Reference: Beaver Valley Power Station, Unit No. 1
Docket No. 50-334
Additional Information Relative to
License Amendment Request No. 25

Beaver Valley Power Station, Unit No. 1
Docket No. 50-334
Additional Information Relative to
License Amendment Request No. 35
Page - 2 -

EVALUATION OF THE
LOW FEEDWATER FLOW REACTOR TRIP SETPOINT
CHANGE FOR BEAVER VALLEY UNIT NO. 1

FIGURE 1 Low Feedwater Flow Reactor Trip Logic
Beaver Valley Power Station Unit No. 1

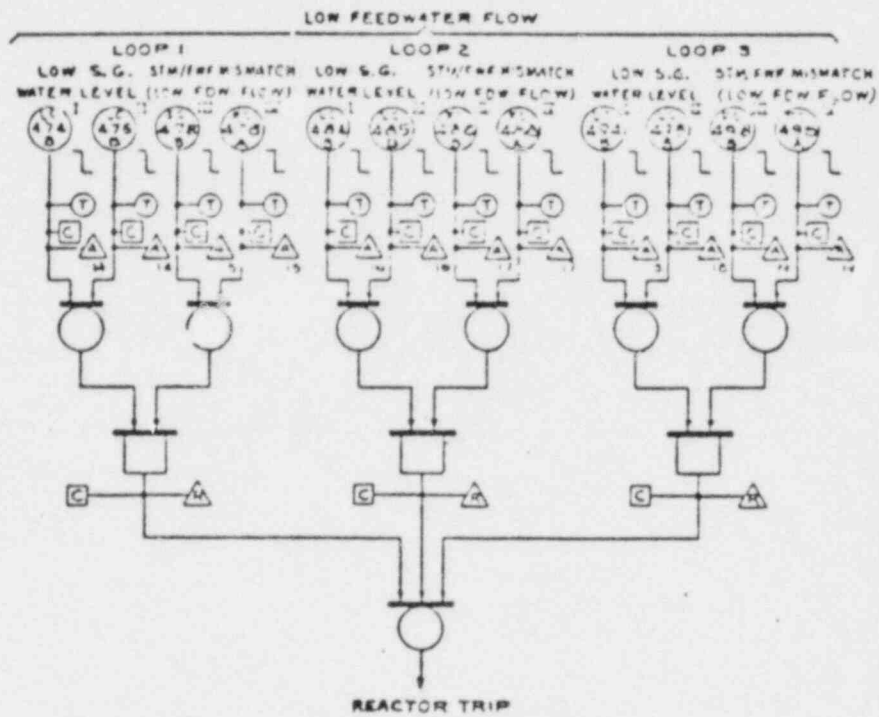
The low feedwater flow reactor trip consists of a steam/feedwater flow mismatch in coincidence with low steam generator water level. A logic diagram for this trip function for a three loop plant is presented in Figure 1. This reactor trip is designed to protect the plant from a sudden loss of the reactor's heat sink, such as a postulated loss of normal feedwater or a major rupture of a main feedwater pipe. At low power levels, the possibility of an unintentional reactor trip from low feedwater flow is greatly enhanced due to manual control of main feedwater flow, minimal margin between programmed steam generator water level and the trip setpoint, and larger steam and feedwater flow measurement inaccuracy. Improvement in operability may be attained by changing any of these three factors affecting the possibility of unintentional reactor trips. The following evaluation investigates increasing the margin to trip through changes to the low feedwater flow reactor trip setpoints, while assuring that adequate protection is provided for loss of heat sink accidents.

- 6) Steam generator heat transfer area is assumed to decrease as the shell-side liquid inventory decreases.
- 7) The steam/feedwater flow mismatch would be generated immediately after the break occurs. The low feedwater reactor trip signal would be generated when the low level setpoint is reached, providing the input to the coincidence logic shown in Figure 1.

Assuming feedline break conditions prior to reactor trip, the only requirement placed upon the steam/feedwater flow mismatch channel is that the signal is present when the low steam generator level setpoint is reached. Because the safety margin will remain unchanged as long as this requirement is satisfied, some operating margin can be realized by raising the steam/feedwater flow mismatch setpoint. Including a sufficient error allowance for the process variable measurement, drift, calibration, and environmental effects, the nominal setpoint may be increased to 70% of steam flow at the licensed power level of 2660 MWt. For the case analyzed, the mismatch would be actuated

The steam/feedwater flow mismatch reactor trip setpoint may be increased to 70% of steam flow at the licensed power level at 2660 MWt. No reduction in the low steam generator water level reactor trip setpoint can be justified at the expense of safety margin for the hypothetical major rupture of a main feedwater line. Attachment 1 to this report shows changes to Table 2.2-1 of the Beaver Valley Unit No. 1 Standard Technical Specification to be consistent with the recommended setpoint changes. Attachment 2 shows similar changes to the Precautions Limitations and Setpoints document.

14. Steam/Feedwater Flow Mismatch and Low Steam Generator Water Level	\geq 70% $< \frac{70\%}{42.5\%}$ of full steam flow at RATED THERMAL POWER coincident with steam generator water level \geq 25% of narrow range instrument span--each steam generator	\geq 72.5 $< \frac{72.5}{42.5\%}$ of full steam flow at RATED THERMAL POWER coincident with steam generator water level \geq 24% of narrow range instrument span--each steam generator

Figure 1
Part Length CRDM - Rollernut Antirotation Housing Details and Assembly

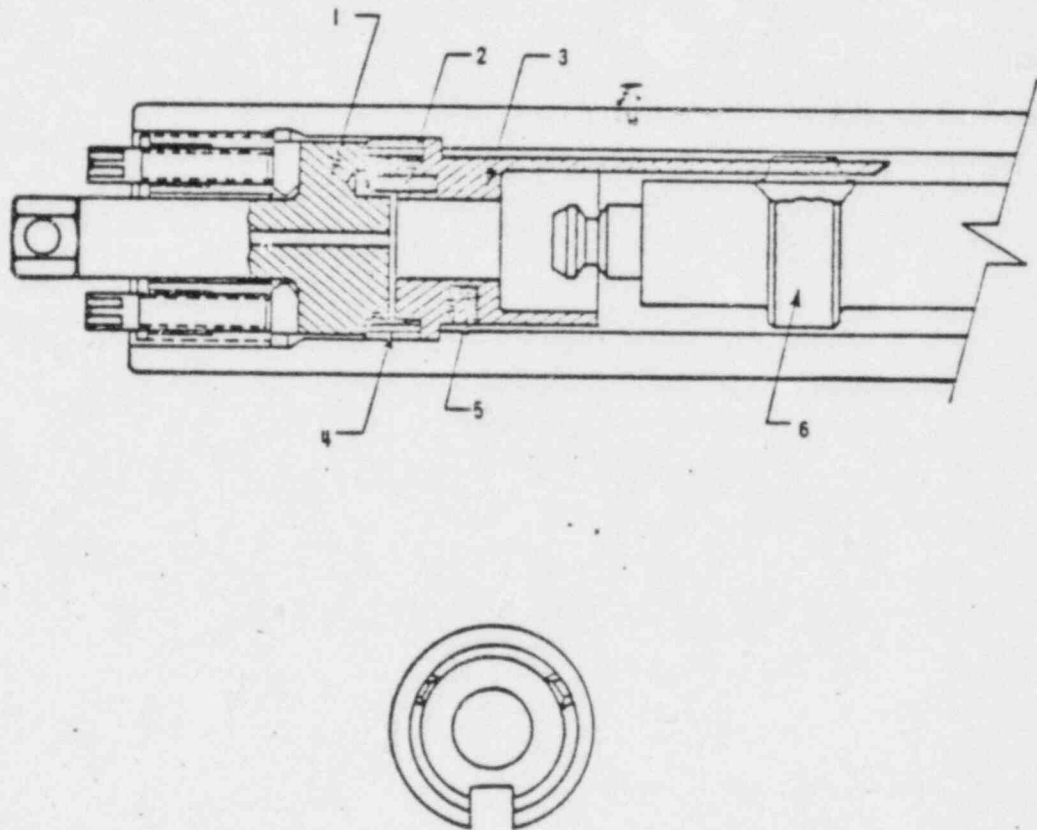
The elimination of the part length rods has been engineered by the Westinghouse Electric Corporation, the reactor supplier. The purpose of removing the part length rods (which we are restricted from utilizing) is to minimize future refueling outage time associated with unlatching and relatching these rods from the lead screw. This time saving is accompanied by a reduction in radiation exposure that would result from the performance of this work. To assure that no thermal hydraulic problems or no changes in upper head fluid temperature will result from removing these rods, a thimble plugging device is inserted in the fuel elements that occupy the core positions presently associated with part length rods. An anti-rotation device is installed on each part length rod lead screw. These leads are left in place.

Three (3) copies of Westinghouse Electric Corporation proprietary sketches of the stainless steel anti-rotation devices are being provided with the three (3) signed originals of this submittal.
